LICENSE AUTHORITY FILE COPY
UNITED STATES
NUCLEAR REGULATORY COMMISSION
WASHINGTON, D. C. 20555

The Commission has issued the enclosed Amendment No. 27 to Provisional Operating License No. DPR-5 for the Indian Point Station Unit No. 1 and Amendment No. 59 to Facility Operating License No. DPR-26 for the Indian Point Nuclear Generating Station Unit No. 2. These amendments consist of changes to the Technical Specifications in response to your application transmitted by letter dated February 26, 1979.

These amendments revise the Technical Specifications concerning the organization for Unit Nos. 1 and 2, the reporting requirements for Unit No. 1, the qualifications of the Chemistry and Radiation Safety Director for Unit Nos. 1 and 2, and the number of fire detectors for Unit No. 2.

SAFETY EVALUATION BY THE OFFICE OF NUCLEAR REACTOR REGULATION
RELATED TO AMENDMENT NO. 27 TO PROVISIONAL OPERATING LICENSE NO. DPR-5
AND AMENDMENT NO. 59 TO FACILITY OPERATING LICENSE NO. DPR-26
CONSOLIDATED EDISON COMPANY OF NEW YORK, INC.

Figure 3.1 Facility Management and Technical Support Organization

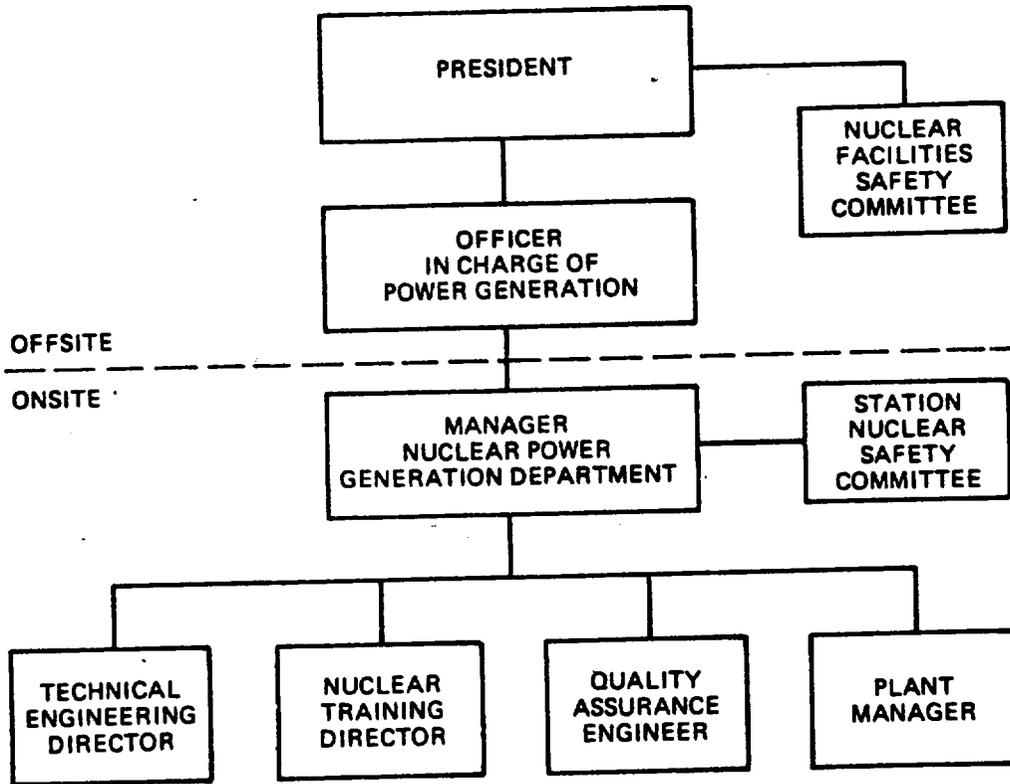
The organization charts (Figures 3.1 and 3.2 for the Unit No. 1 and Figures 6.2-1 and 6.2-2 for Unit No. 2) have been changed to reflect the above changes, as well as to delete reference to Unit No. 3 which is no longer owned or operated by the licensee.

3.1.1 The organization for facility management and technical support shall be as shown in Figure 3.1.
